Your ref: 1906-11653 SRA

Gold Coast Council Ref: COM/2019/81

Re: Nucrush Quarries Pty Ltd, 33 Maudsland Road, Oxenford

Attachment A1 - Development application claims approved footprint is 56.02 hectares (1)

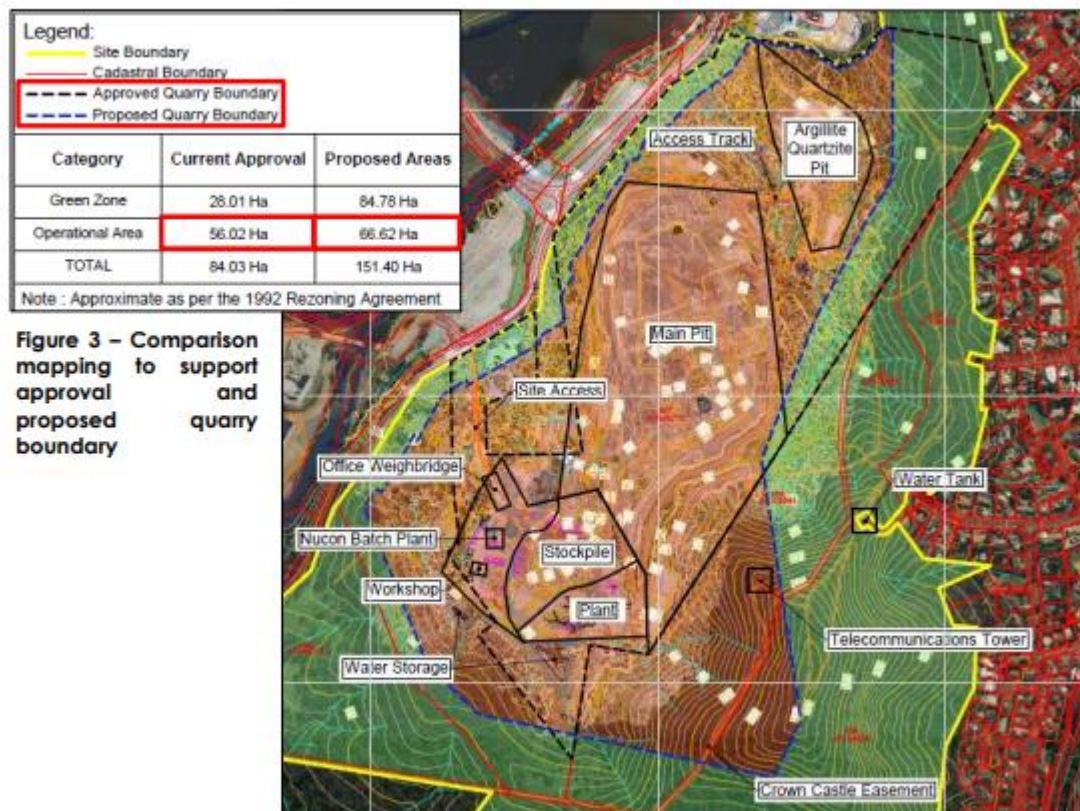
At the time of SARA referral and subsequent approval it was claimed that the current approval was 56.02 hectares and the development application was to increase this by only 10.6 hectares (an increase of 18%) as shown on Page 10 of the development application (reproduced in Attachment A1). This claim is also repeated on page 19 (reproduced in Attachment A2).

The proposal seeks to enlarge and realign the extraction footprint by approximately 10.6 hectares.

Accordingly the new footprint will ultimately have a total operational footprint of 66.62 hectares.

Attachment A4 - Deputy Director-General of DES assures me the approved extraction area is approximately 55.4 ha

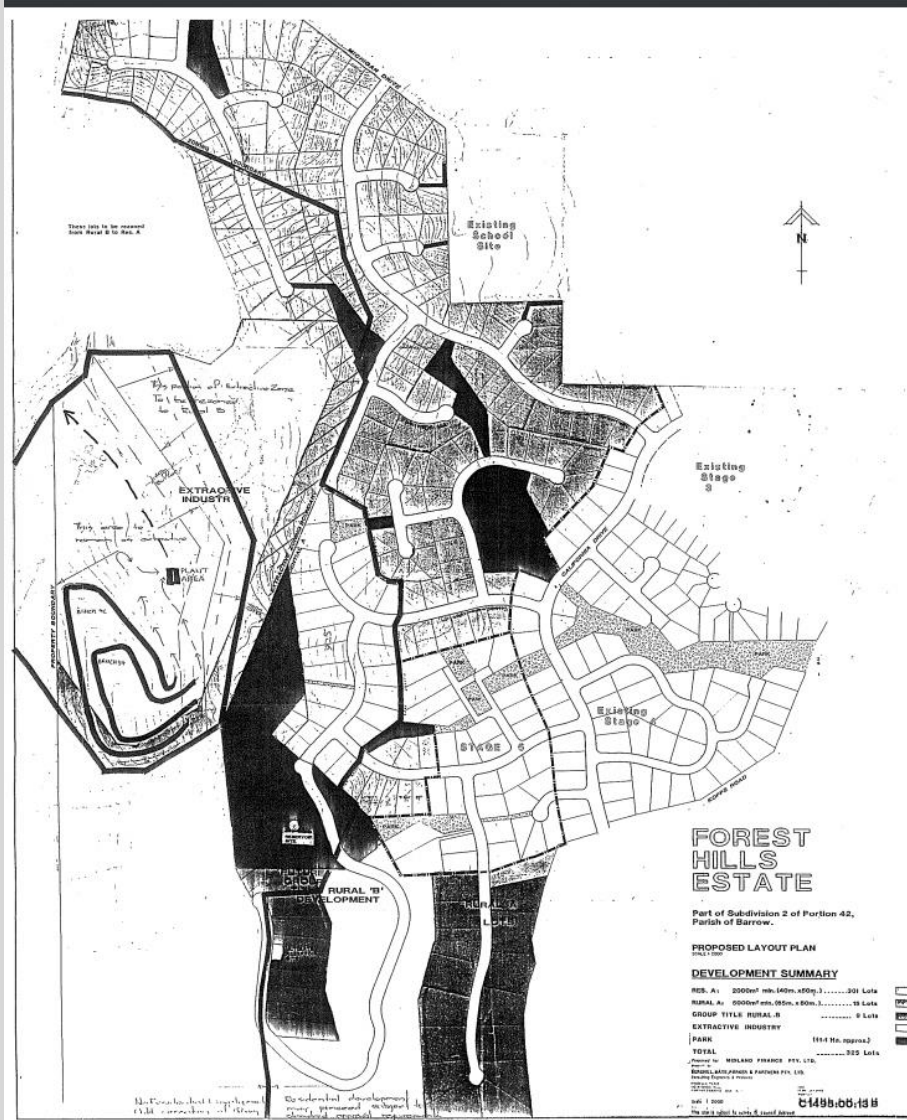
The SARA original referral was based on these incorrect claims of a relatively insignificant increase in extractive footprint is confirmed in my correspondence with Mr Rob Lawrence, the Deputy Director-General of the DES, re the SARA approval. He confirmed their approval was based on (quote from his email dated 26th June 2020): *"The previous approved extraction area was approximately 55.4ha in size ... making the current approval of 66ha an expansion of 10.6 ha"* (reproduced in Attachment A4). When he dismissed my claims out of hand.

It should be noted that the current EA does not represent an expansion of 3.6 times the previously approved extraction area. The previous approved extraction area was approximately 55.4ha in size, with only 31.8ha disturbed to date, making the current approval of 66ha an expansion of 10.6 ha.

Attachment B1 - Plan C1495:00:13B

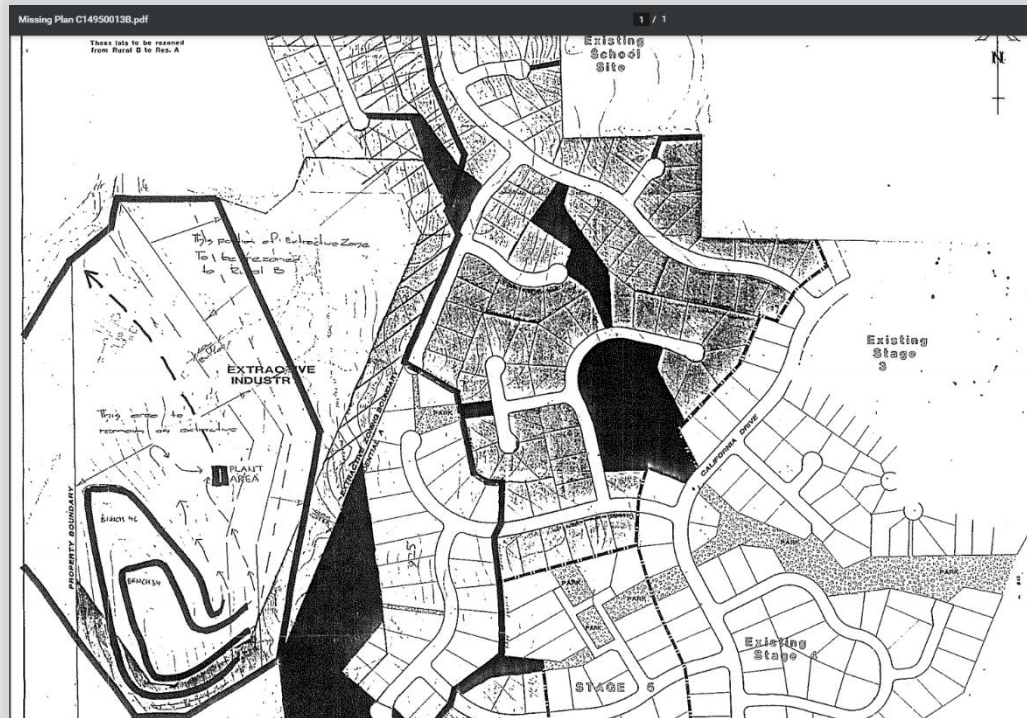
This being the 'Third Schedule' (or 'Plan 362-010' as it is also referred to) of the Rezoning agreement, dated 17th March 1992 (annotated version reproduced in Attachment A3) and development plan 'C1495:00:13B' (reproduced in Attachment B1, with a close up in B2 and annotated version for clarity in B3).

'B' as agreed. This prohibited development area is labelled on Plan C1495:00:13B' as: *"The Portion of Extractive Zone to be rezoned as Rural 'B' "* (as shown in Attachment B1 and annotated in Attachment B3 for clarity). As shown on page 6 of the Deed of Novation (reproduced in Attachment C3), which is another crucial document (dated 12th September 1989) pertaining to this development application that has been, seemingly culpably omitted by the applicant.

Attachment B2 - Plan C1495:00:13B (Showing close-up of Rural 'B' area)

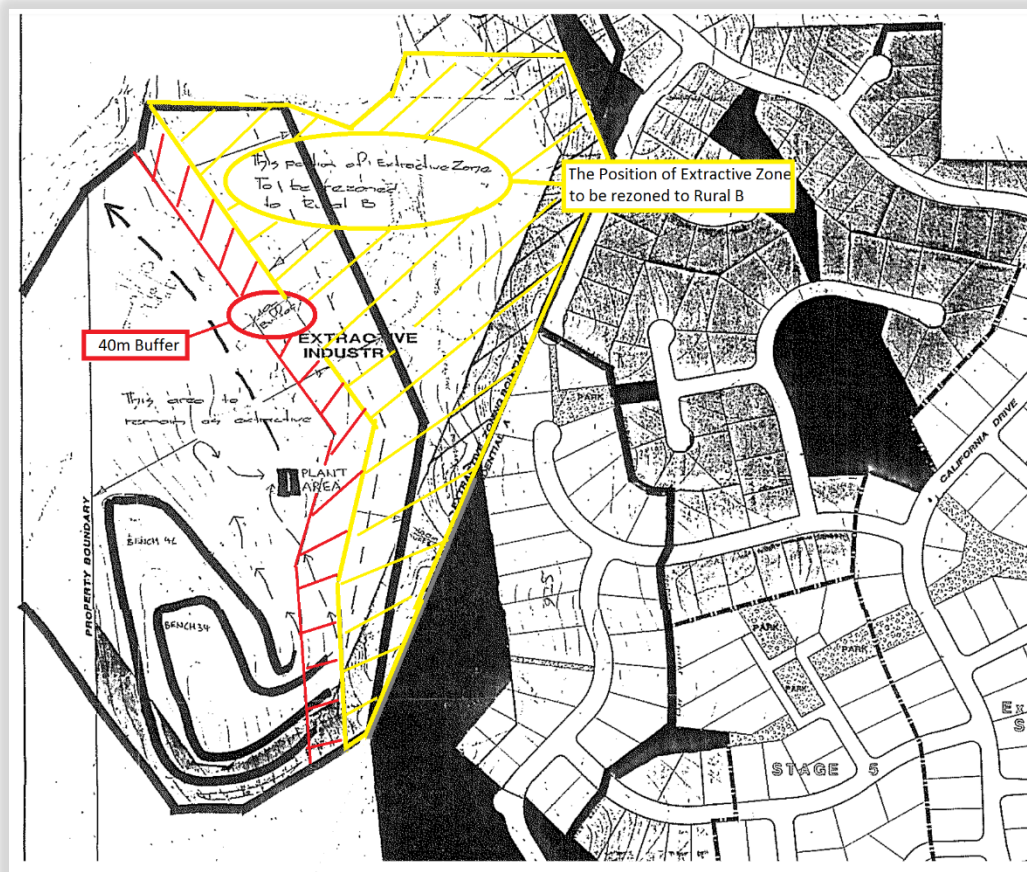
(Note the judge in this case indicated the Rural 'B' is an area of 10.5 hectares. However, I believe this is incorrect assumption and this is based on the smaller area identified in Attachment B4 identifying an earlier extractive footprint. The Rural 'B' area was subsequently defined as a result of the David Kershaw report, who was a geologist, who attempted to establish relative harmony between the proposed residential development to the east and the quarry to the west, the result is clearly shown in Attachments B1, B2 and B3, which is approximately 16.6 hectares).

Attachment B4 - DA submitted Fourth Schedule of Rezoning agreement seemingly altered to appear as the 'Third Schedule'

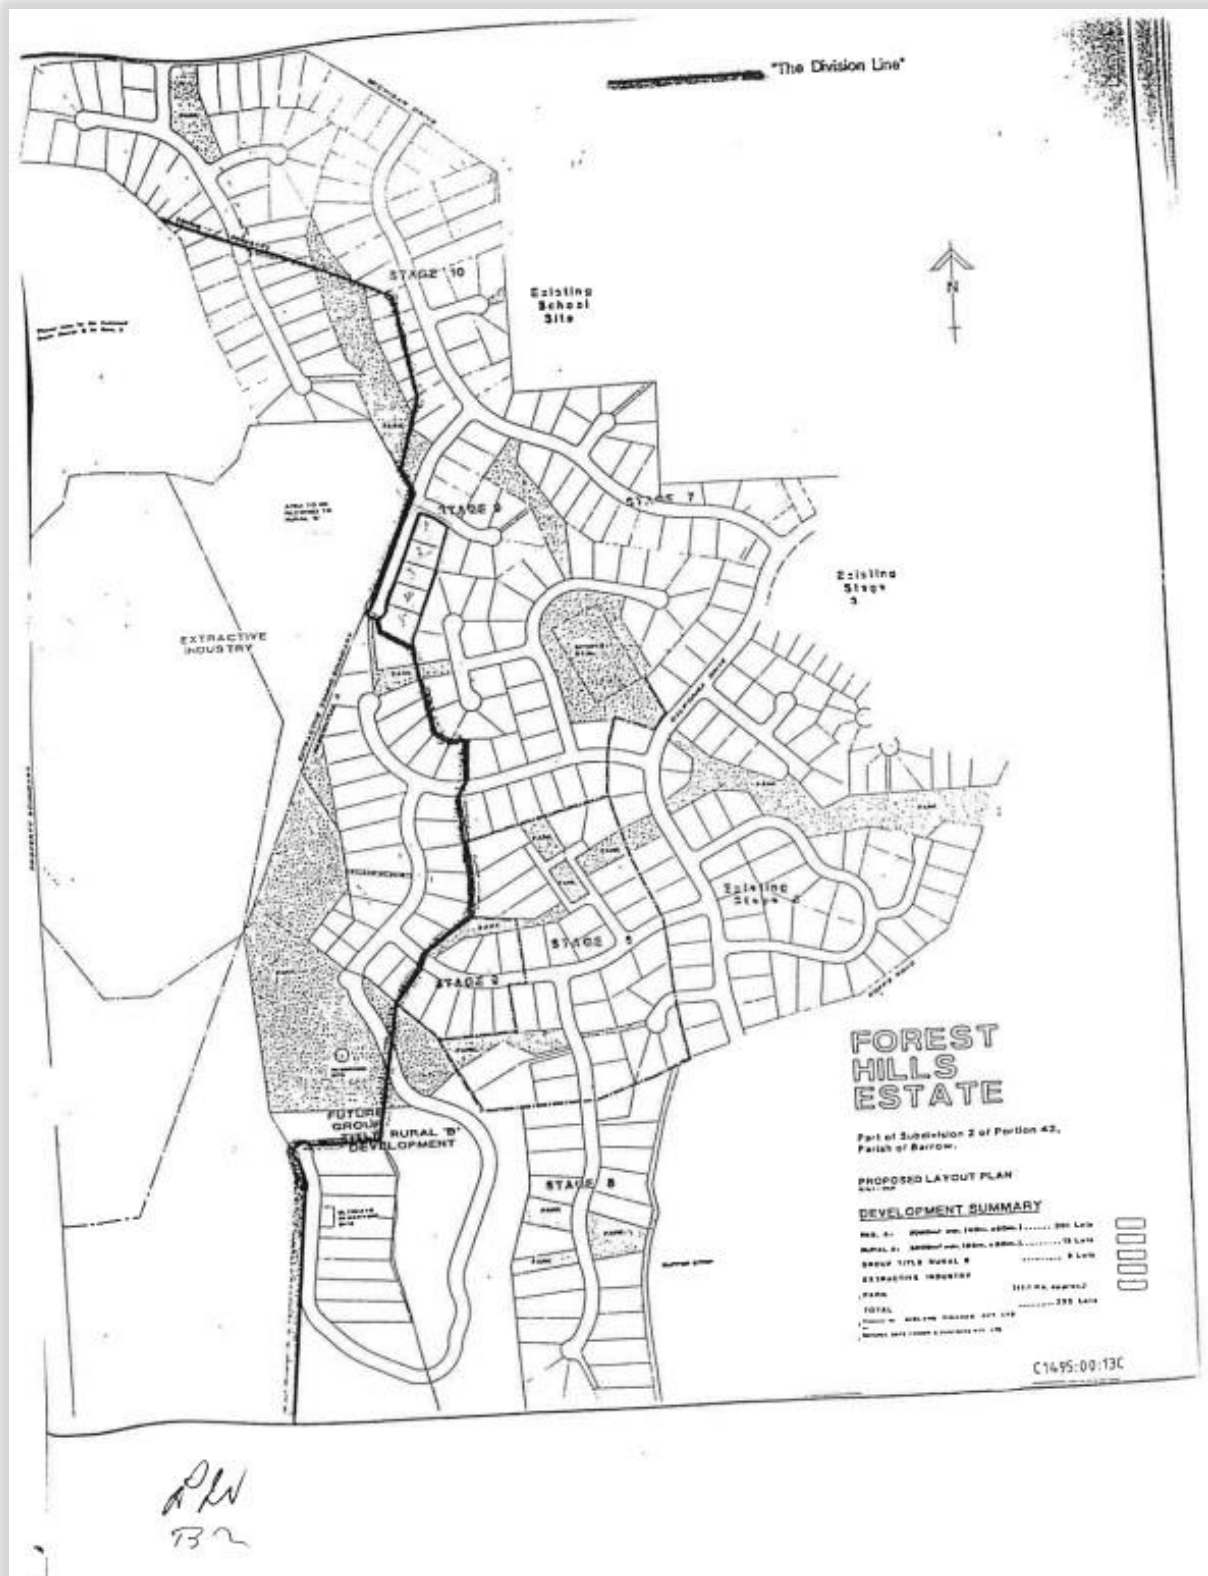
The highly important 'Third Schedule' was, it would appear, removed from the submitted copy of the Rezoning agreement and replaced with the relatively innocuous 'Fourth Schedule' with its title removed (See Attachment B4). The original is reproduced in Attachment B5 with its 'FOURTH SCHEDULE' title intact. In fact, if you examine these two pages alongside each other (Attachment B4 and Attachment B5), it would seem, not only has the title been removed, but the signature at the bottom appears to be changed also (A close up of the Original Rezoning agreement Fourth Schedule is reproduced in Attachment B6 and the submitted copy in Attachment B7).

In my opinion, this apparent removal of the title: 'FOURTH SCHEDULE' in order, I believe, to appear to be the 'Third Schedule' is a fraudulent misdirection, I believe, to hide the status of the 'Buffer Land' and 'Permanent tree and shrub screening' protected areas.

Note title 'FOURTH SCHEDULE' has been removed. Original shown in Attachment B5 below.

Attachment B8 - Court Order to amend applicaton as per Plan of Development No. 362-010

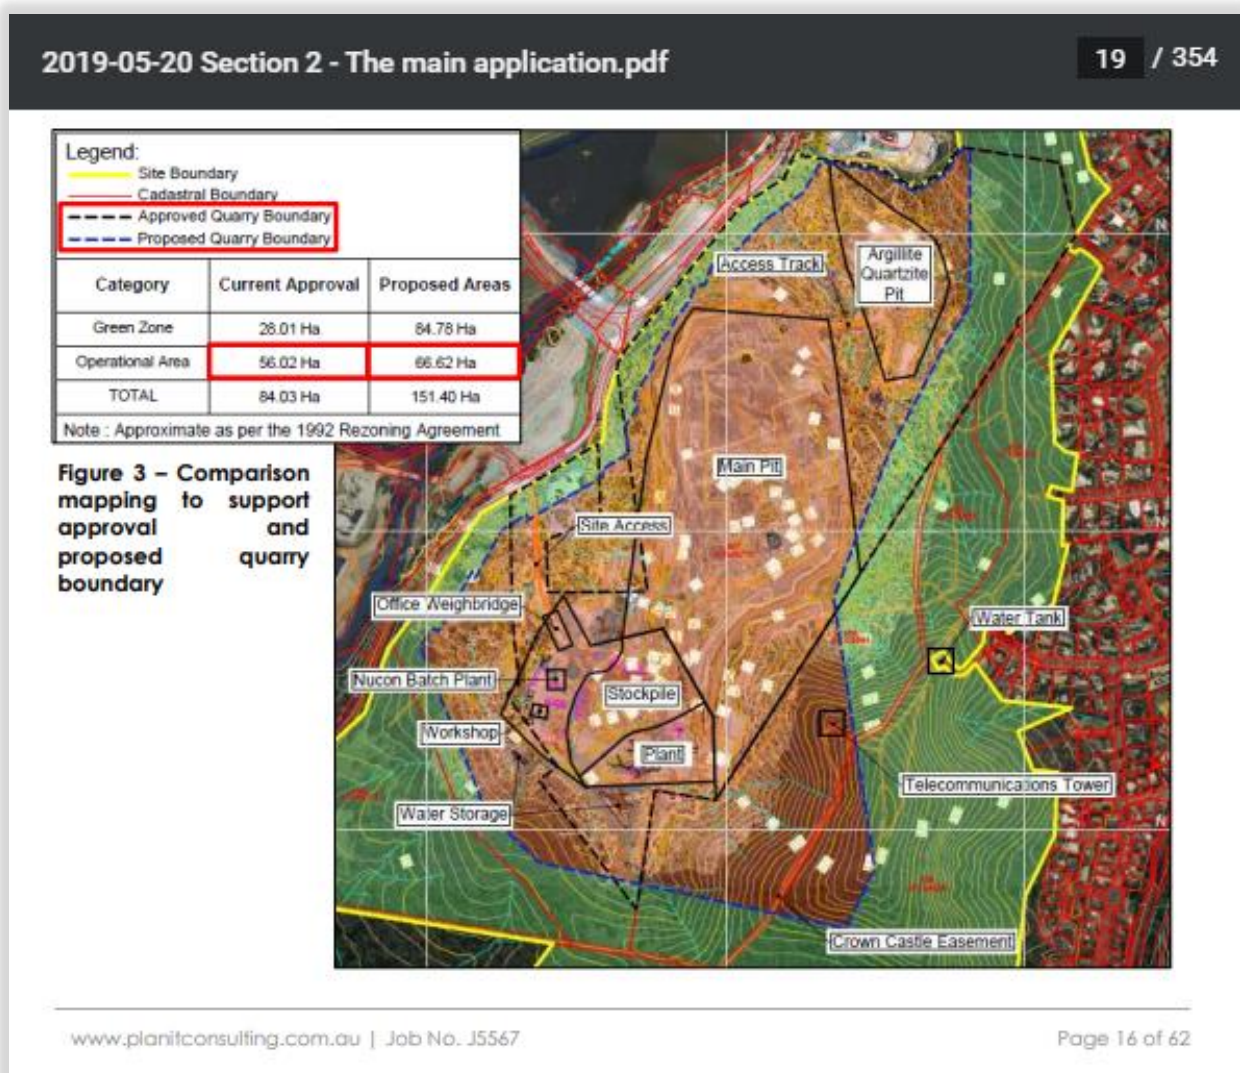
Please note in the Rezoning Agreement (dated 17th March 1992) Section F (page 2) states: *"On 17th April 1991, the Court Ordered that the application be amended in accordance with the Plan of Development No. 362-010 dated 5th April, 1991 which plan is the Third Schedule of this Deed, and that the appeal be allowed in respect of that Amended Application as shown on the said Plan of Development"* (Attachment B8).

The main development application claims on page 9: *"The changes to the approved quarry footprint involves extending the footprint to the southeast and southwest whilst reducing the footprint to the northeast"* (Attachment C1). These changes are shown on page 19 of the main application in diagrammatic format showing the claimed 'Current approval' and the 'Proposed extractive footprint;' (Reproduced in Attachment C2).
